Design Competition Report

201 Elizabeth Street, Sydney
Architectural Design Competition Report

Submitted to City of Sydney
On behalf of Dexus Property Group

4 December 2018 | 14262

Figure 1 SJB competition submission

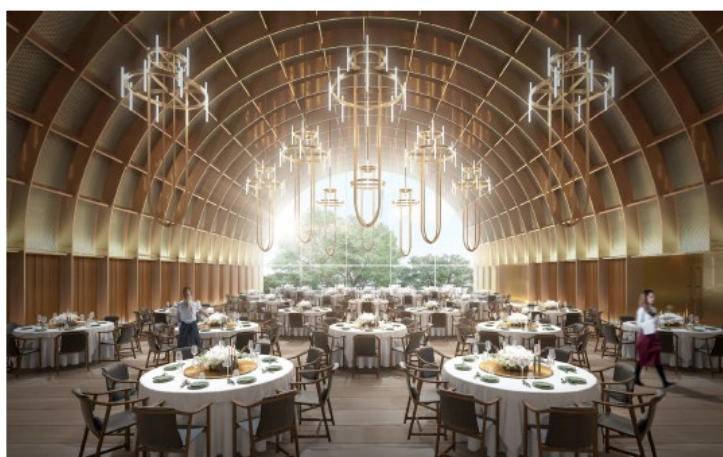
The Jury sought further clarification from SJB to address technical advice relating to the structural solution, the expression of the tower and its architectural language, as well as to more closely align the submission with the target land use mix and yield within the Brief.

Although the additional material addressed a number of the Jury’s initial concerns, the Jury were of the view that the SJB scheme would require significant design changes to resolve the tower expression and hotel efficiency. The Jury also noted that the SJB scheme continued to present a number of structural and cost challenges.
